## Burnley Pendle Growth Corridor Junction K Church Street / Active Way

Stage 1 Road Safety Audit

## Burnley Pendle Growth Corridor Junction L A670 Active Way / Westgate / Queens Lancashire Way / St. James's Street Crossroads

## Burnley Pendle Growth Corridor Junction O Dunkenhalgh Way / Blackburn Road Junction

Figure A.1 : Vehicles turning right through gaps in waiting traffic into Sandygate.

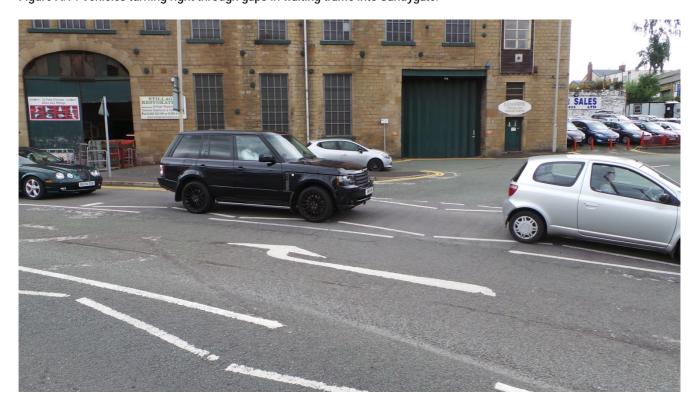
Vehicles were observed to queue on Queens Lancashire Way blocking the access to Sandygate for vehicles looking to turn right into or right out of Sandygate. This is due to vehicles waiting for pedestrians to cross the controlled crossing or by waiting at the give way of the roundabout. It is recommended that a yellow box marking is provided to ensure this area of the northbound lane is kept clear. (Refer to photo A.2).

Figure A.4 : High level signal head may be obscured by tree canopy at new location

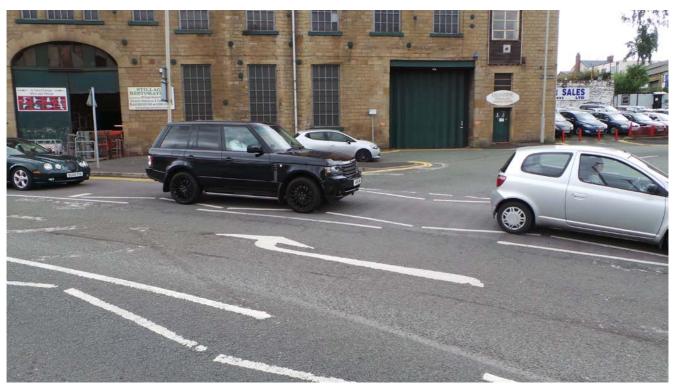
The high level signal aspects associated with the relocated crossing on Queen's Lancashire Way may become obscured due to the adjacent tree on the western side of the road, as is currently experienced by lamp column number 3.

Figure A.5: Existing footway directing pedestrians into junction and not across estate access

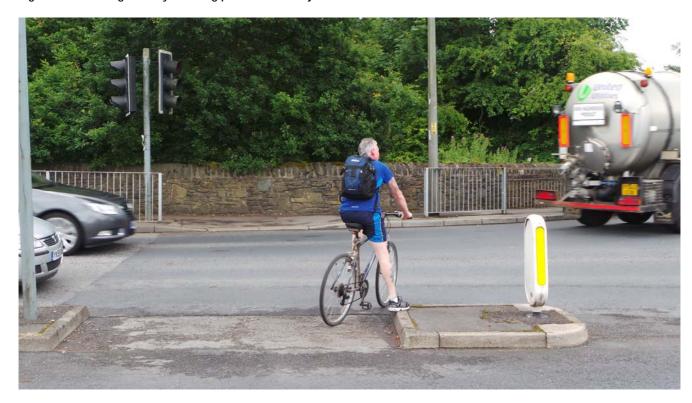
Concern is expressed that there is an existing access to an industrial premise located to the north-west of the junction which is currently closed off, however the future operation of this access is unknown. Should the access be maintained, then it is unclear whether the existing footway will be amended to include dropped kerbs

and tactile paving. Failure to provide adequate crossing facilities could result in pedestrians coming into conflict with vehicles causing serious injury. (Refer to photo A.2).

The future use of the access should be determined and should the access be reopened the dropped kerbs and tactile paving should be installed across the access.
